The Cloth and Fashion Ltd.

Client Summary Report

Observations & Actions

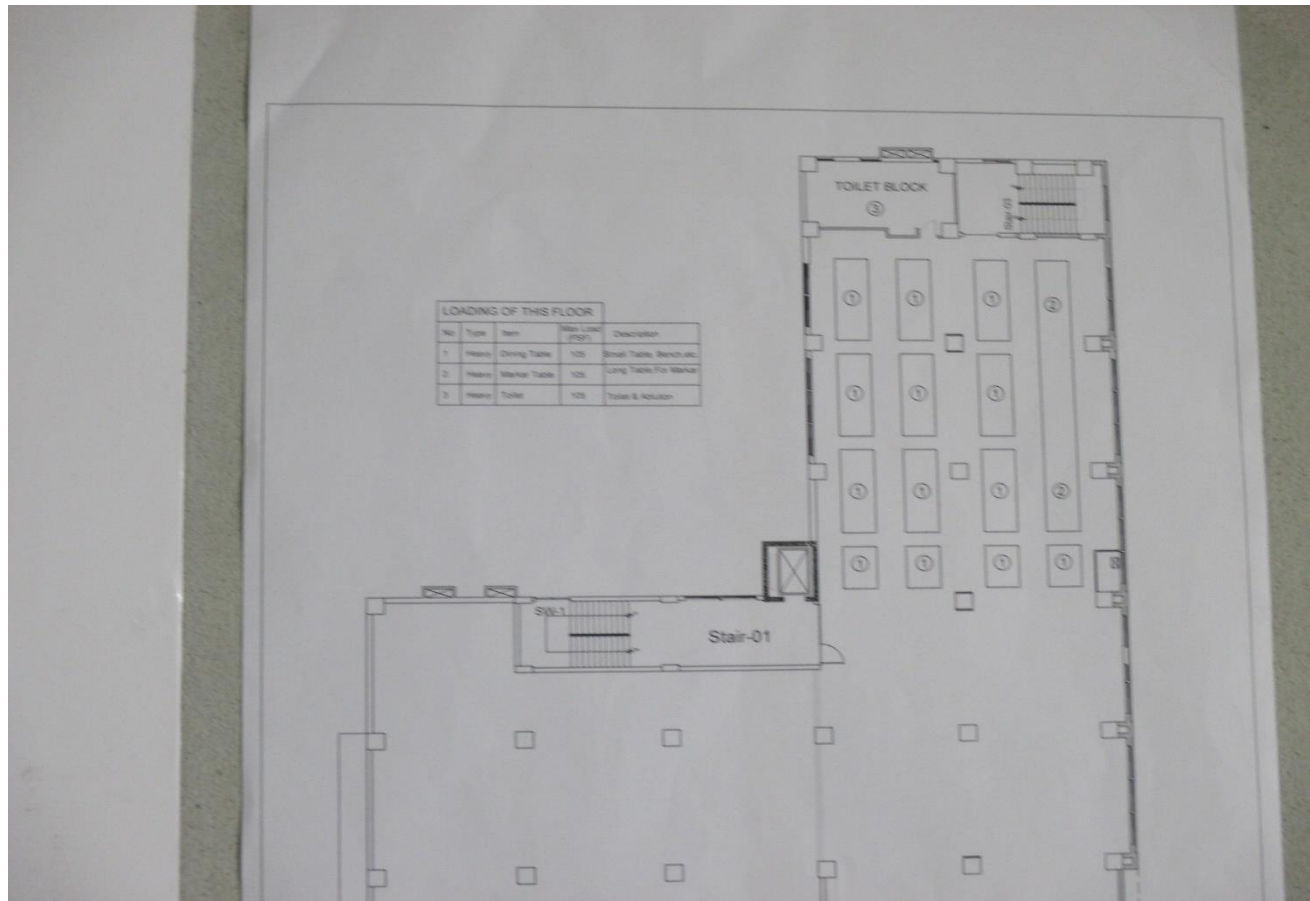
Inconsistent and Missing Documents

In Architectural and Structural drawing there was no specific position and section of overhead water tank.

Observation : Main Factory Building.

Load plan for 105 Psf was posted at each floors but relevant document was not found

Observation : Main Factory Building.

- Produce and actively manage a loading plan for all floor plates within the factory giving consideration to floor capacity and column capacity.
- Update as built drawing of main factory building considering position and section of Overhead water tank.
